Proposed Changes for SPI-4

00-246r4

Paul Aloisi TI

The driver/receiver electrical changes proposed for SPI-4

Figure 49 Paced Timing diagram and the paragraph under the figure TBDs replaced a table expect for the free running clock which is 100 mV.

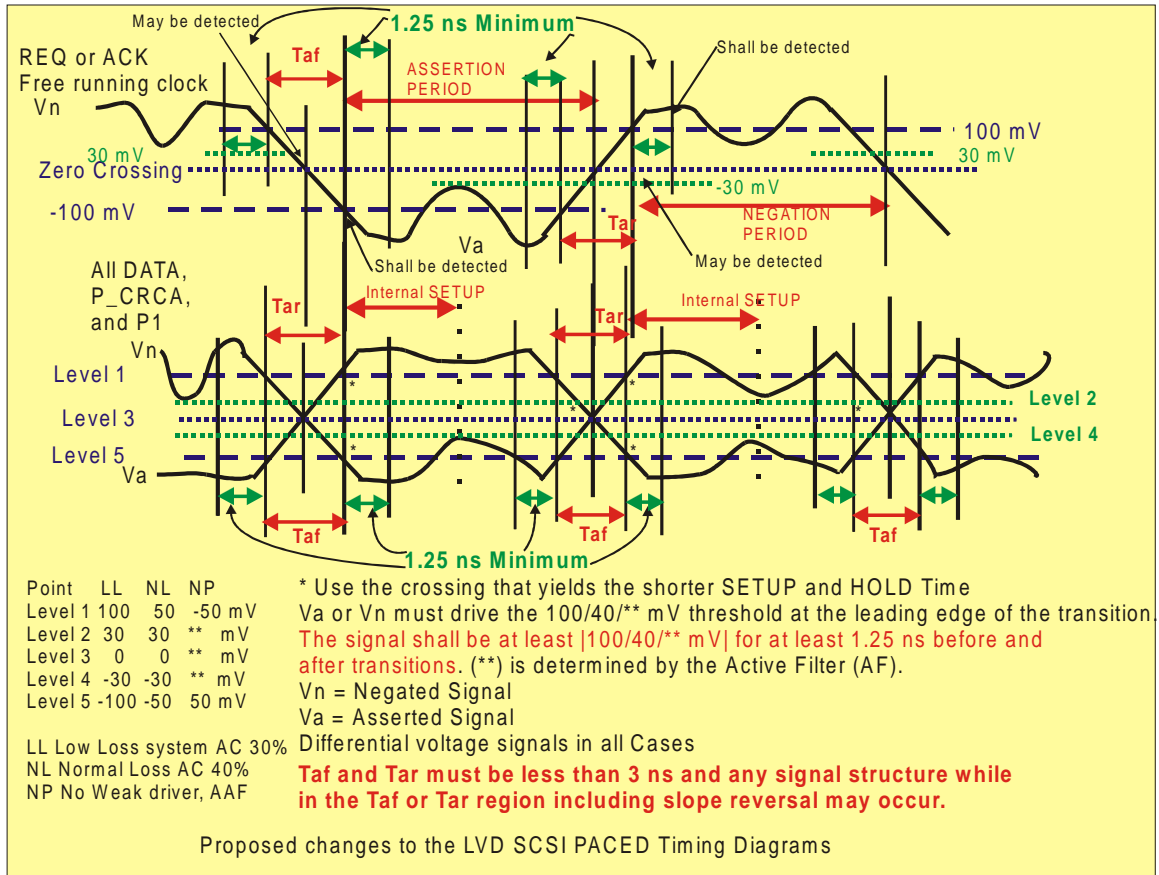
Low Loss (LL)

The signal shall transition for LL (low loss systems) from -100 to +100 mV or +100 to -100 mV in 0 to 3 ns, the waveform between -100 and +100 mV is not otherwise specified. The absolute value of the signals shall remain above the 100 mV level for 1,25 ns at each end of the transition. The absolute value of the signals shall not drop below 30 mV except during the transitions (see 7.3.2).

Normal Loss (NL)

The Free running clock shall transition for NL (normal loss systems) from -100 to +100 mV or +100 to -100 mV in 0 to 3 ns, the waveform between -100 and +100 mV is not otherwise specified. The other signals, the first transition from the multiple bit level shall transition -100 to +50 mV or +100 mV to -50 mV, if there is an immediate transition the +50 mV to -100 mV or -50 mV to +100 mV. The absolute value of the signals shall remain above the 100 mV multiple bits or 50 mV for a single bit level for 1,25 ns at each end of the transition. The absolute value of the signals shall not drop below 30 mV except during the transitions (see 7.3.2).

Weak driver off / AAF Adaptive Active Filter (NP)

The Free running clock shall transition for NP (no weak driver systems) from -100 to +100 mV or +100 to -100 mV in 0 to 3 ns, the waveform between -100 and +100 mV is not otherwise specified. The other signals, the first transition from a multiple bit level shall transition at least 150 mV and shall be a minimum 50 mV from the zero crossing, example -200 mV level shall transition to -50 mV for a valid transition.

The absolute value of the multiple bit signals shall remain above the 100 mV for 1,25 ns at each end of the transition. The absolute value of the signals shall not drop below 30 mV except during the transitions (see 7.3.2).

Fast-160 Receiver Mask NL for isolated assertion or negation pulses, during the data transitions +/-1.1 volt maximum with reflections

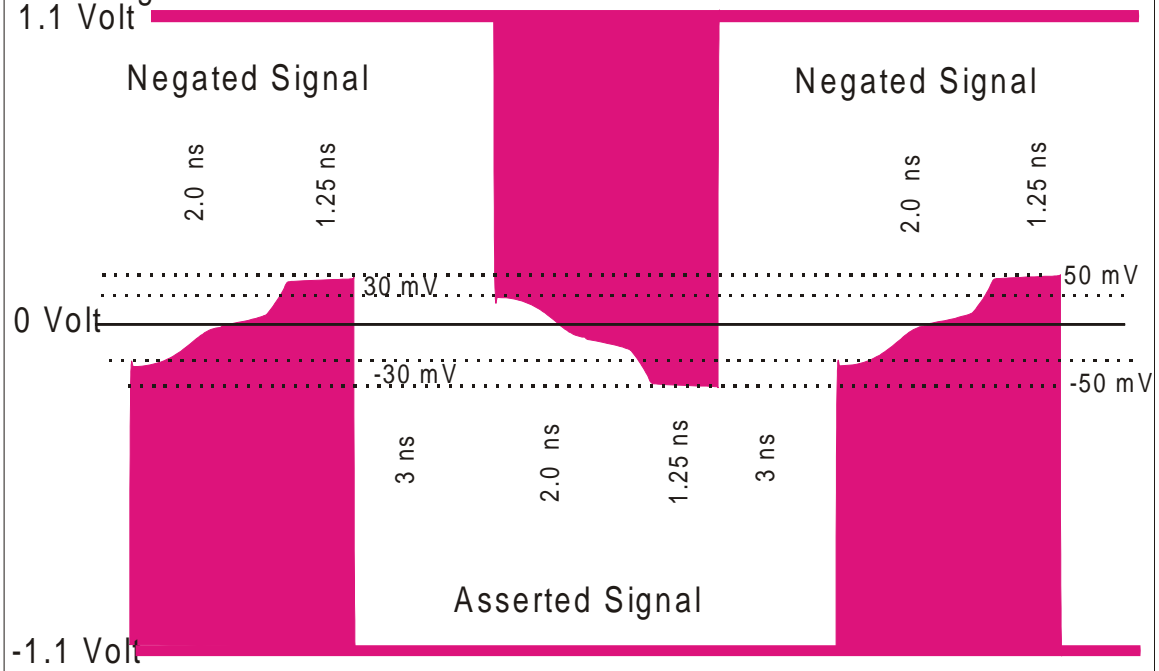
The ratio of the Peak before the transition to the Peak at the end of the next bit time in the 1.25 ns range.

Fast-160 Receiver Mask NP, during the data transitions
+/-1.1 volt maximum with reflections

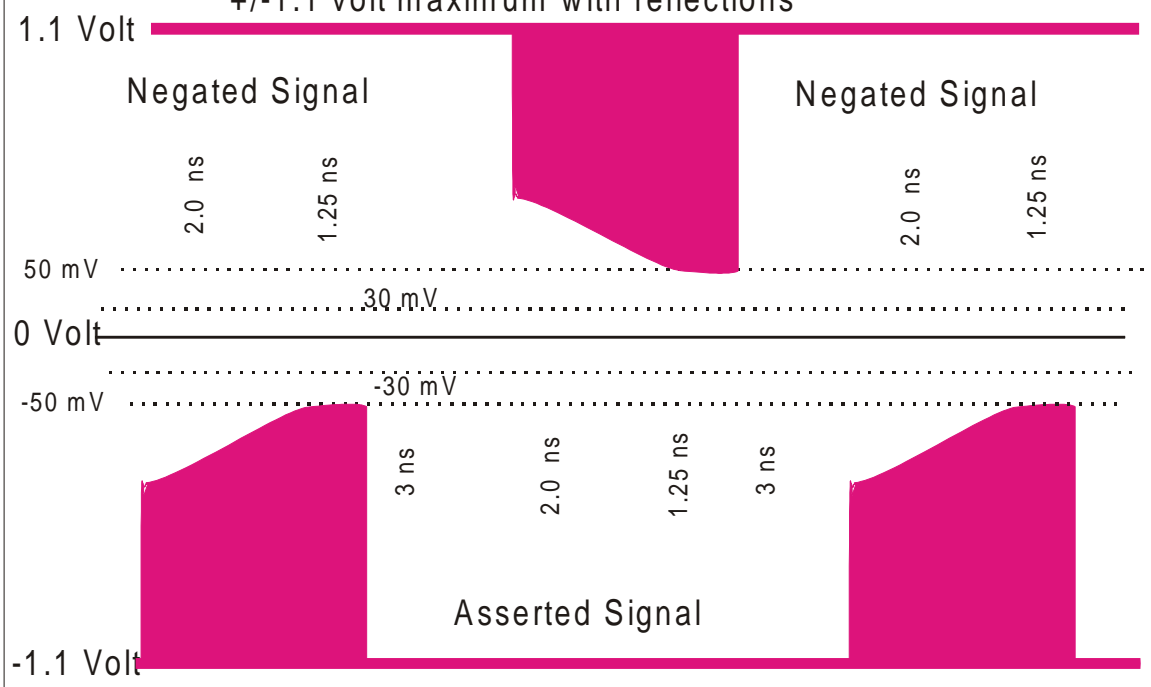
The ratio of the Peak before the transition to the Peak at the end of the next bit time in the 1.25 ns range shall transition 150 mV minimum.
